PRODUCT CHANGE NOTIFICATION

Bourns® EMS Non-Contacting Absolute Encoder Connector Change

Model EMS22A and EMS22Q Series

Comparison

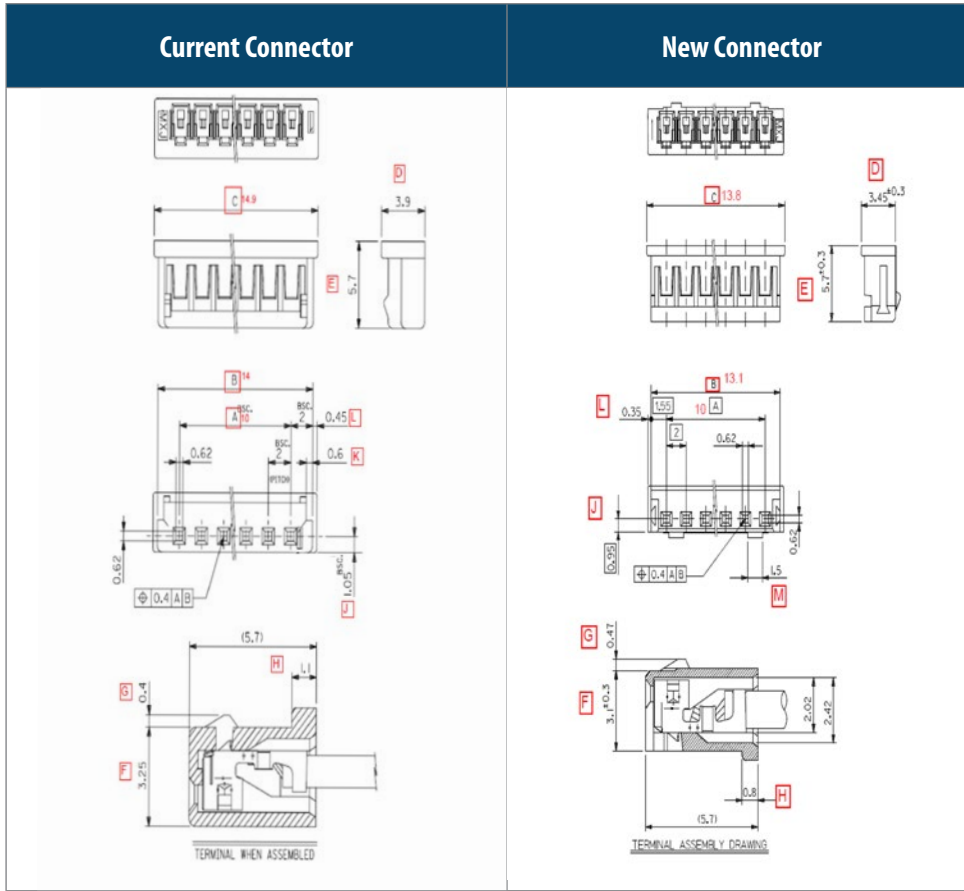
Riverside, California – May 26, 2020 – Effective immediately, the connector used for the Bourns® Model [EMS22A](#) and [EMS22Q](#) series will be changed to the Molex 051065-0600. The current connector has been discontinued by the manufacturer. The dimensions of the Molex 051065-0600 are slightly different than the original connector but the replacement connector is made with comparable materials. The change in dimensions shown on the following page could impact the customer's application. Affected part numbers are listed below.

The change in dimensions will affect the form and fit of the product. This change will have no effect on the function, quality or reliability. Samples for evaluation are available upon request.

Description	Current P/N: 051090-0600	Replacement P/N: 051065-0600	Replacement meets spec
Agency Certification			
CSA	LR19980	LR19980	✓
UL	E29179	E29179	✓
Physical Specification			
Color - Resin	Natural	Natural	✓
Flammability	94V-0	94V-0	✓
Gender	Receptacle	Receptacle	✓
Glw-Wire Capable	No	No	✓
Material - Resin	Polyester	Polyester	✓
Net Weight	197.000/mg	159.700/mg	✓
Number of Rows	1	1	✓
Pitch - Mating Interface	2.00mm	2.00mm	✓
Temperature Range - Operating	-40° to +105°C	-40° to +105°C	✓
Dimensional			
DIM A	10	10	✓
DIM B	14	13.1	X
DIM C	14.9	13.8	X
DIM D	3.9	3.45 ± 0.3	X
DIM E	5.7	5.7	✓
DIM F	3.25	3.1	X
DIM G	0.4	0.47	X
DIM H	1.1	0.8	X
DIM J	1.05	0.95	X
DIM K	0.6	missing	X
DIM L	0.45	0.35	X
DIM M	missing	1.5	X

Dimension: MM
Note: For this replacement the mating connector must be changed to manufacturer series P/N: 53253 or P/N: 53254
